## Different technical modifications and updatings on baby 24V

### → Starting from serial number: 12003882 dated 19/11/12 **baby plus**

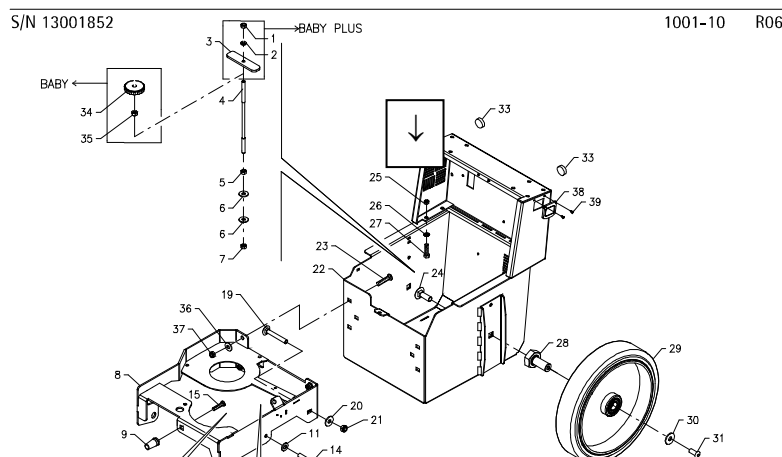
We have updated the spare parts catalogue of the electrical layout **CRE 1012-20** with revision **R01**, replacing the part number of the battery charger with the new one, 64602029 (see also spare parts catalogue, table 1012-30 R03).

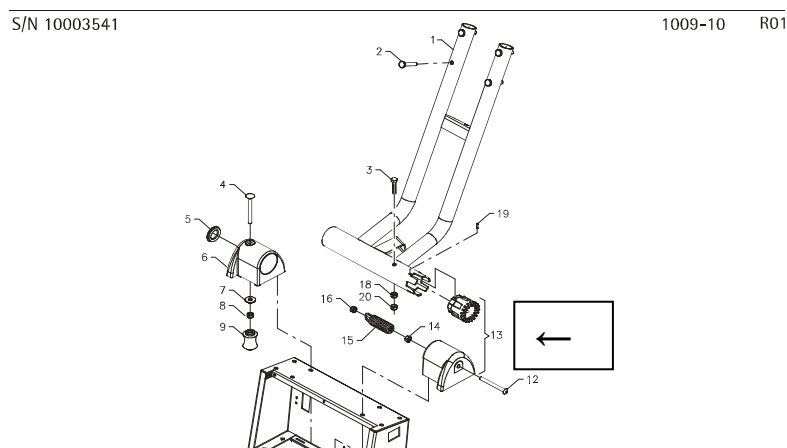
The new battery charger (64602029) is double insulated and therefore it does not have the ground wire as the previous one. To comply with the Class I it is necessary that the central contact of the plug input is grounded. We add therefore a new connecting cable 49810016 with yellow/green colours. Furthermore, we add the grounded connection screw (pos. 27), nuts (pos. 25) and lock washers (pos. 26) to ensure the contact.

table 1012-10 R02 (pos. 10)

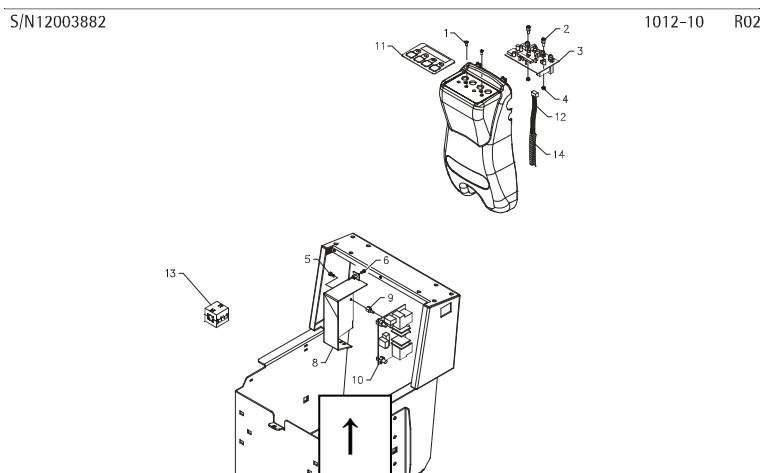
From the analysis of the replaced check cards and the damages occurred, we have verified that often the problem was the 30A relay of the brushes motor. To improve the reliability we have modified the check card inserting a 40A relay with revision index 3. The updated check card relay (49705030) is interchangeable with the previous one.

tables: 1009-20 R03 (pos. 26) / 1013-10 R01 (pos. 23)

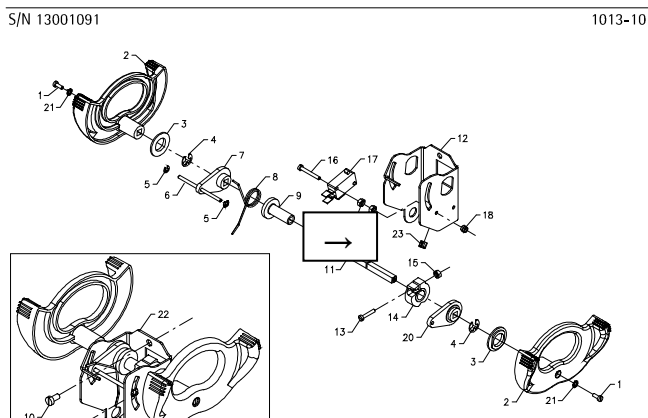
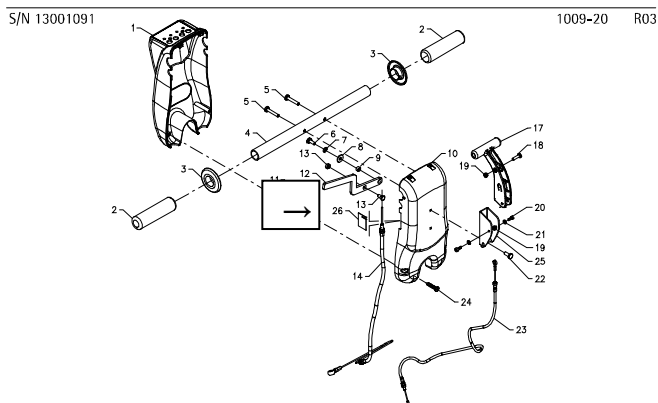
With regard to the safety rules we intervened by adding positions 26 and 23. The new protection (pos. 26) inserted near the slot of the control lever ensures the protection degree IP23.

The clip (pos. 23) is fixed onto the drive control support to prevent the cables of the general switch (presence) coming into contact with the moving parts.

We have added a ground label (No. 65001020) inside the battery compartment near the connection screw of the ground conductor.

1012-30 R04

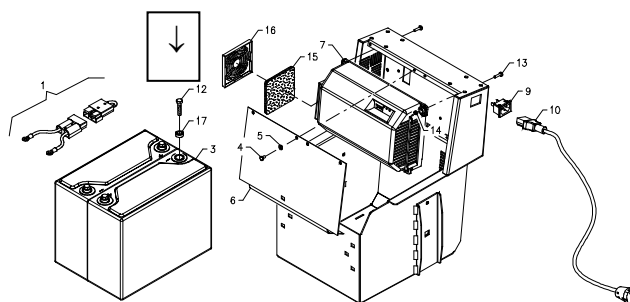
We have introduced a new spacer (pos. 17) between each pole and cable eyelet to obtain a safe air distance towards the plastic parts of the battery covering.
